INNER WEST COUNCIL

DEVELOPMENT ASSESSMENT REPORT

Application No.	D/2018/546
Address	55 Church Street, LILYFIELD NSW 2040
Proposal	Demolition of existing dwelling-house and construction of 2X2 storey semi-detached dwellings with garages and associated works, including landscaping and tree removal, fencing works, and Torrens title subdivision into 2 lots.
Date of Lodgement	19 October 2018
Applicant	T Polvere
Owner	Velopo Nominees Pty Ltd
Number of Submissions	2 objections
Value of works	\$900,000
Reason for determination at Planning Panel	Clause 4.6 variation exceeds officer delegation
Main Issues	Lot Size, FSR, Solar Access, Amenity Impacts, Site Layout and Building Design, Desired Future Character
Recommendation	Refusal
Attachment A	Draft conditions (if not refused)
Attachment B	Proposed Plans
Attachment C	Clause 4.6 - Floor Space Ratio
Attachment D	Clause 4.6 – Minimum subdivision lot size

Figure 1: Proposed ground floor at No. 55 Church Street.

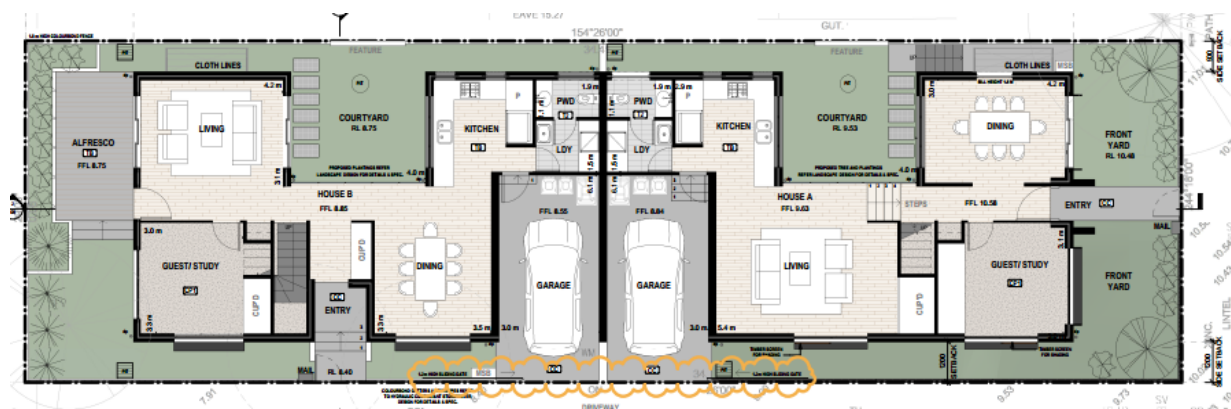
The proposal involves demolition of existing structures and subdivision to create two lots with an area of 173sqm each. The proposal (as amended) provides two x two storey semi-detached dwellings each containing three bedrooms, two bathrooms and rumpus room on the first floor; ground floor kitchen, living and dining area, fourth bedroom and separate laundry and toilet; and ground floor courtyard and semi-enclosed single car space with access off Frazer Street. New fencing and landscaping works are proposed to soften the appearance of the development.

Figure 6: Existing pattern of development. The blue lines indicate ground floor BLZ.

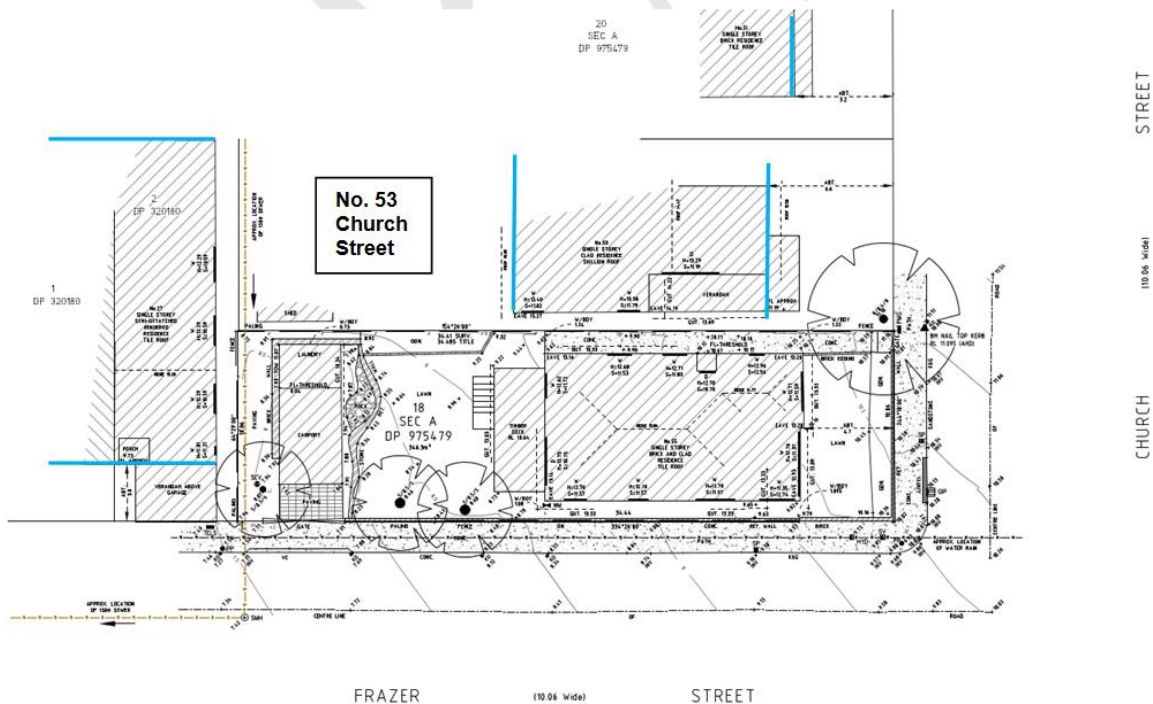
Control C5 requires the BLZ of a corner site to be determined by the location of the building on the adjacent property that most resembles the orientation, frontage width and site layout of the subject site. The single storey dwelling at 53 Church Street has a front setback of 6.6m and rear setback of 14.4m. In this instance, the proposal varies the ground floor BLZ with front and rear setbacks of 3.2m, and seeks to establish a new first floor BLZ

Whilst Control C6 enables a variation to the BLZ, it is considered that the applicant has not satisfactorily demonstrated that the proposed building is consistent with the pattern of development in the immediate locality (usually taken as the same street) and that:

- The proposed new dwellings will establish a first floor building location zone that result in any adverse amenity impacts upon the surrounding properties in terms of solar access;
- The proposal does not comply with FSR and does not provide a suitable area within the rear of the property to accommodate vegetation and a large canopy tree;
- The proposal will not provide a compatible area of private open space and outdoor recreation with an acceptable level of solar access for the occupants;
- The proposal is not considered to be compatible with the scale and character of surrounding development.
